DESIGN <i>KE</i>	DRAWN BY <i>CP</i>	DART AEROSPACE LTD HAWKESBURY, ONTARIO, CANADA	
CHECKED <i>KE</i>	APPROVED <i>HA</i>	DRAWING NO. DEO 9126	REV. A SHEET 1 OF 1
DATE 98.12.14		TITLE DIMENSION CLARIFICATION	SCALE NTS
A	98.12.14	NEW ISSUE

DART ENGINEERING ORDER

AMEND DRAWINGS D2764 REV. D AND D2846 REV. A

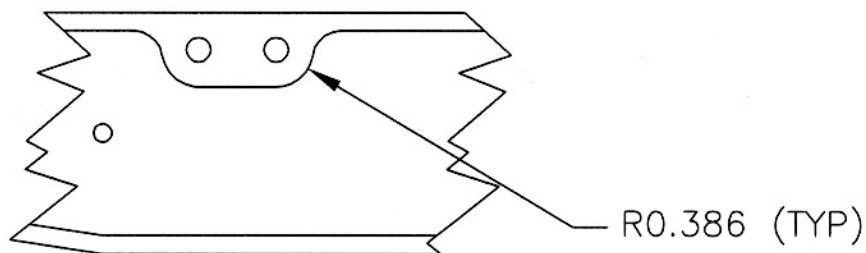
D2764 REV. D
CHANGE RADIUS AS FOLLOWS:

D2846 REV. A
ADD RADIUS AS FOLLOWS:

REASON FOR ENGINEERING ORDER:
TO CLARIFY LUG RADIUS
